Access Compliance Report

Public Rights-of-Way

Intersection ID: 16724	Main Street: CHARLOTTE_PARK_DR	Cross Street: PRESSLEY_RD	Location: NE
ADA ID: 244EC94D3584	Ramp Type: Perp	Initial Pass/Fail: Fail	Overall Compliance: No
Severity Score: 10			
Codes/Mitigation Info/Possible Solution		Field Measurements/Component Compliance

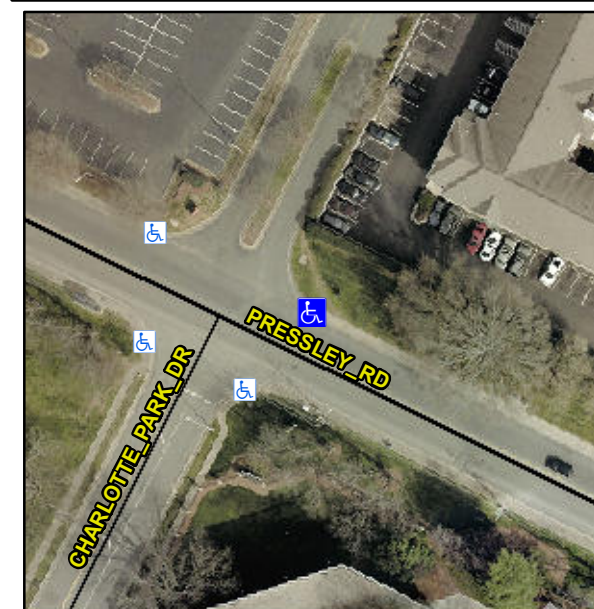
Not Found, R304.5.1, R304.5.3

Compliance	Description	Data	Compliance	Description	Data
N/A	Ramp Length (in)	35.0	Yes	Ramp Slope (%)	7.5
No	Ramp Width (in)	45.0	No	Ramp XSlope (%)	2.7
N/A	Flare Type LT	N/A	N/A	Flare Type RT	N/A
N/A	Flare Slope LT (%)	N/A	N/A	Flare Slope RT (%)	N/A
N/A	Flare Traversable LT?	N/A	N/A	Flare Traversable RT?	N/A
N/A	Landing Length (in)	N/A	N/A	DWS Provided?	N/A
N/A	Landing Width (in)	N/A	N/A	DWS Contrast?	N/A
N/A	Landing Slope (%)	N/A	N/A	DWS Length (in)	N/A
N/A	Landing X Slope (%)	N/A	N/A	DWS Full Width?	N/A
N/A	Landing Curb? (Y/N)	N/A	N/A	DWS Offset (in)	N/A
N/A	Shared Landing?	N/A			
N/A	Gutter Ponding?	N/A	N/A	Gutter Slope (%)	N/A
N/A	Gutter Lip Ht (in)	N/A	N/A	Gutter X Slope (%)	N/A
N/A	Painted X Walk1?	No	N/A	Painted X Walk2?	N/A
	X Walk 1 Direction	To SW		X Walk 2 Direction	N/A
N/A	X Walk 1 Width (in)	N/A	N/A	X Walk 2 Width (in)	N/A
	X Walk 1 Slope (%)	9.5		X Walk 2 Slope (%)	N/A
	X Walk 1 X Slope (%)	0.6		X Walk 2 X Slope (%)	N/A

Remove & Replace Entire Ramp.
